HOPE CREEK GENERATING STATION  
DOCKET NO. 50-354  
DRAFT SAFETY EVALUATION REPORT  
OPEN ITEM STATUS

DSER Open Item No. 5 a, b and d (DSER Section 2.4.5)

## WAVE IMPACT AND RUNUP ON SERVICE WATER INTAKE STRUCTURE

QUESTION 410.69 (Section 9.2.1)

**SERVICE WATER INTAKE  
STRUCTURE - FLOOD  
PROTECTION**

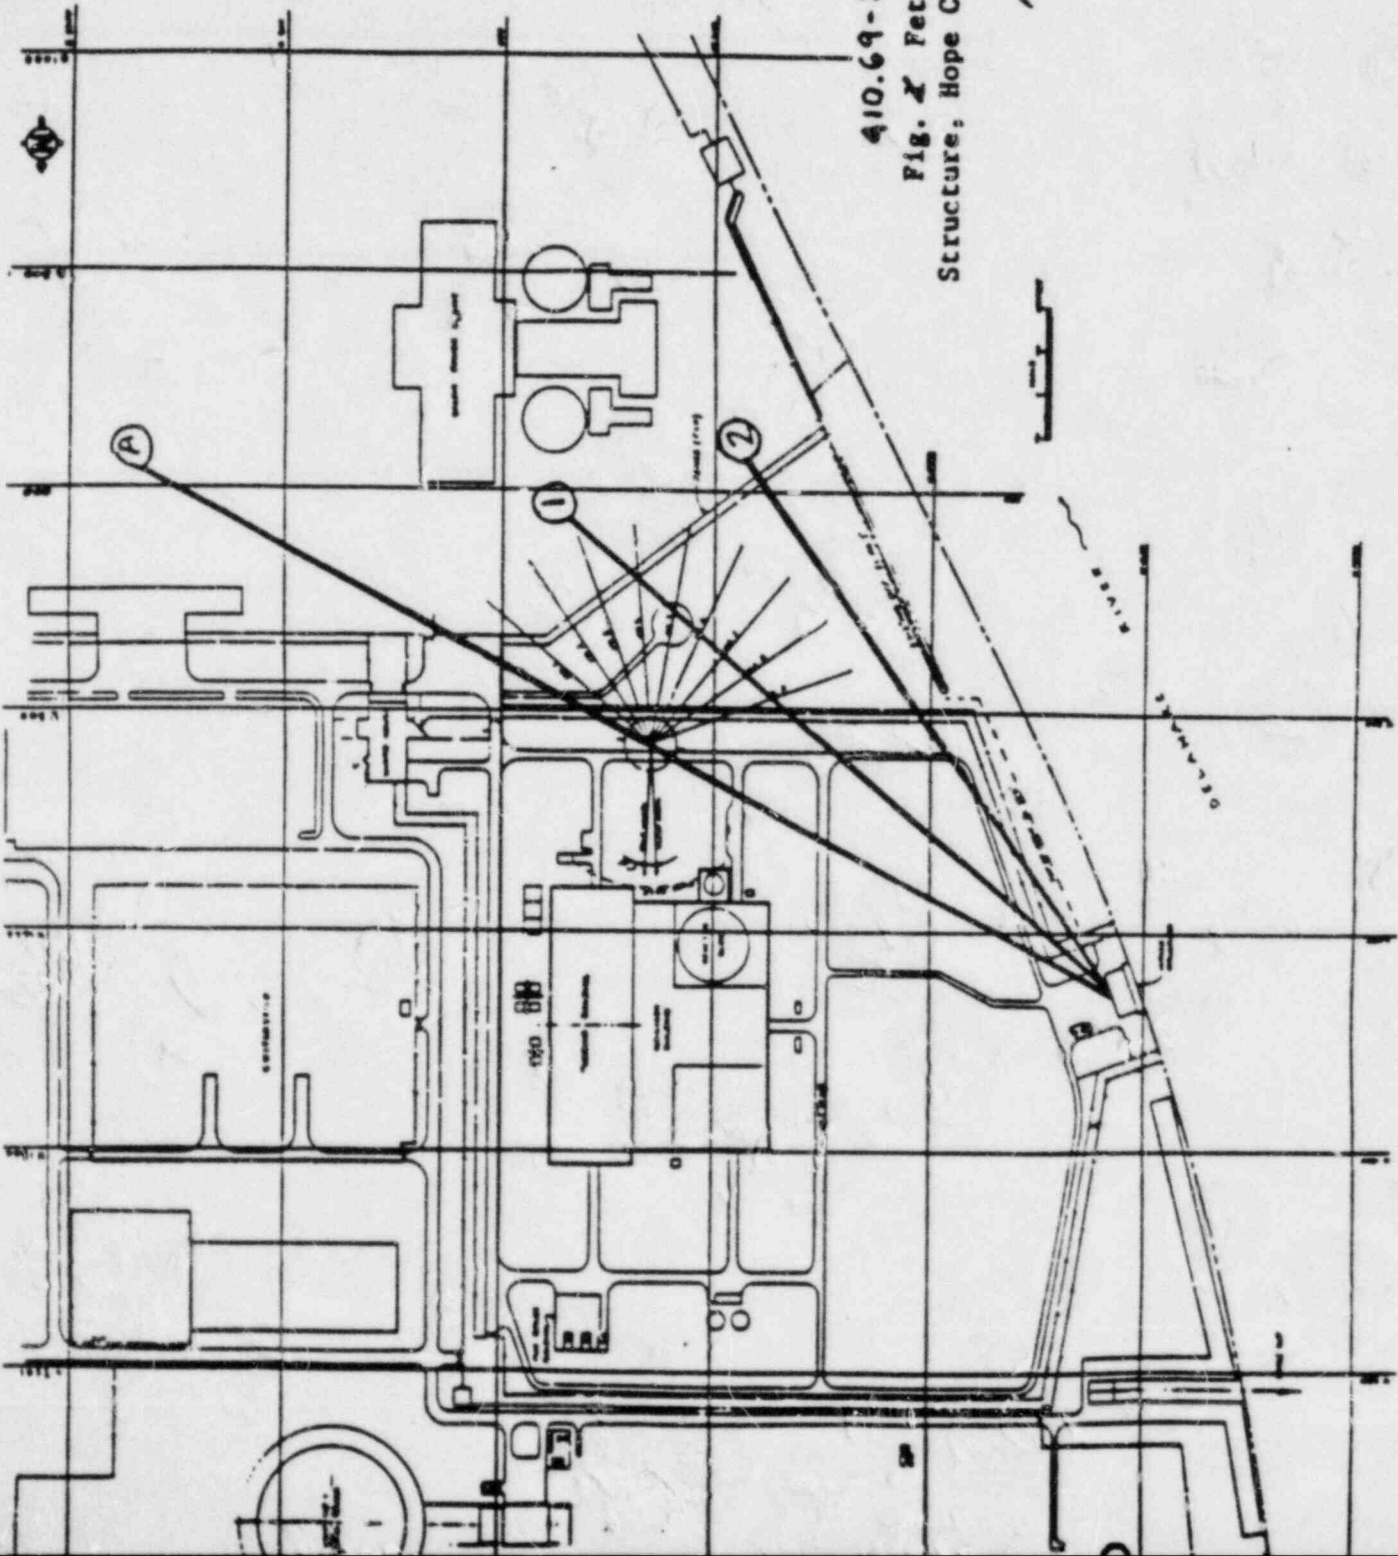
Provide a figure(s) in the FSAR which shows the protection of the station service water system from the flood water (including wave effects) of the design basis flood.

The general arrangement of the intake structure is provided in Figures 1.2-40 and 1.2-41. Section AA of Figure 1.2-41 is reproduced here as Figure 410.69-1 which identifies the watertight areas and the walls and slabs designed to accommodate flood loads. As described in Sections 2.4.2 and 2.4.5, the south and west exterior walls of the intake structure are subject to a maximum wave run-up elevation of 134.4 feet due to the probable maximum hurricane (PMH). Such waves could overtop the roof of the western portion of the structure at elevation 128 feet. However, a rigorous analysis has been performed to determine the depth of water in the low area (elevation 122.0 feet) after wave impact and to confirm that water does not enter the building through the air intake control dampers (bottom elevation 128.5 feet). Therefore, flood water will not enter into the dry area of the intake structure. On the north side of the intake structure, the maximum water level will be only slightly higher than the still water elevation (113.8 feet) during the PMH. According to Table 2.4.6, the maximum wave elevation for the north side of the intake structure is 26.3 feet MSL (elevation 115.3 feet) due to a postulated multiple dam break. Therefore, flood protection of the north exterior wall to elevation 121.0 feet is adequate.

Fig. 2 Fetches for Service Water Intake  
Structure, Hope Creek Generating Station.

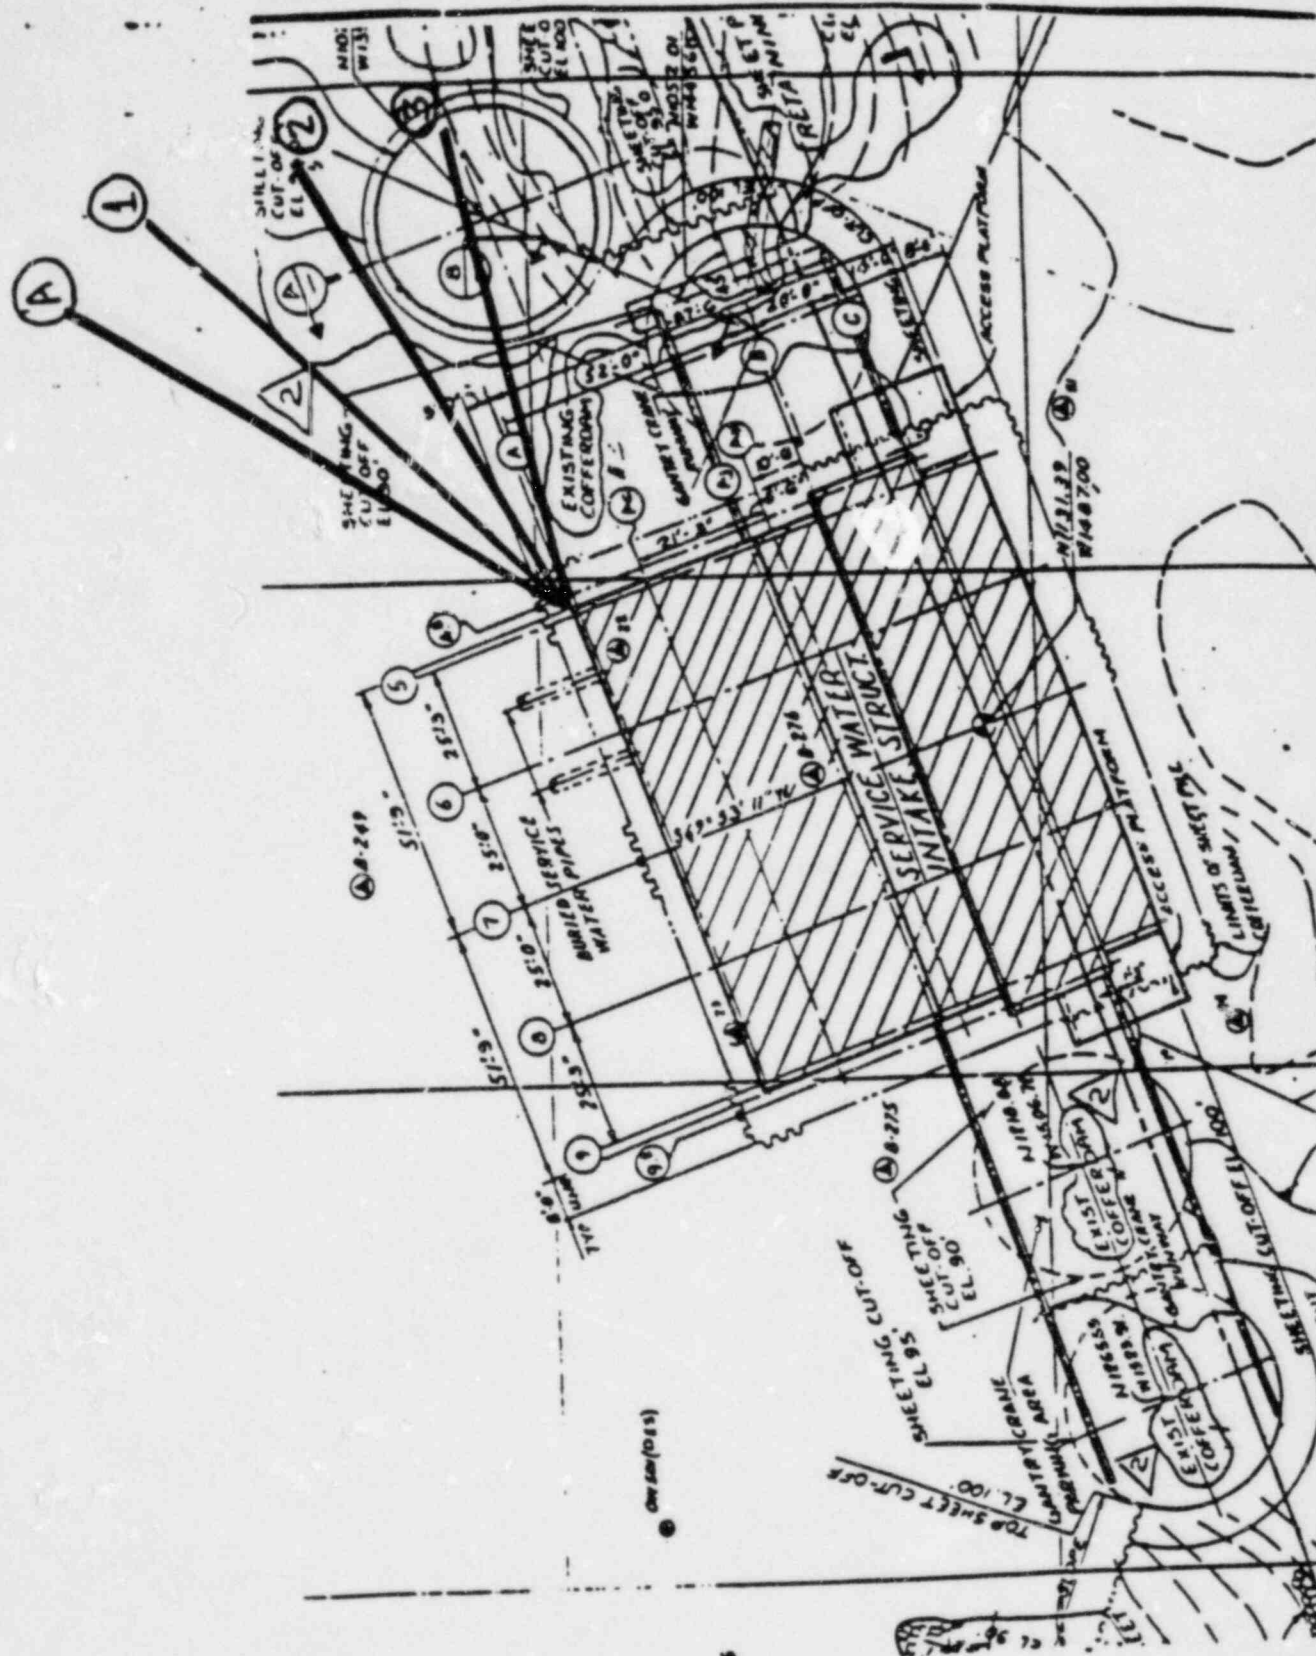
The staff has requested the applicant to provide additional information on the waves that impact on the river face of service water intake structure. The waves impacting on this face of the structure are not reduced in height (depth-limited) as those that traverse plant grade.

On the east side of the intake structure, the maximum wave run-up elevation due to the PMH equals 121.97 feet. This elevation is due to a 18 wave traveling in the direction of Fetch "A". Fetch A, which is rotated about 15 degrees from Fetch 1 (as shown in Figures 410.69-2 and 410.69-3), is chosen to maximize the wave run-up elevation. Since this elevation is lower than the bottom of the HVAC exhaust opening, flood water will not enter the intake structure from the east side of the building.
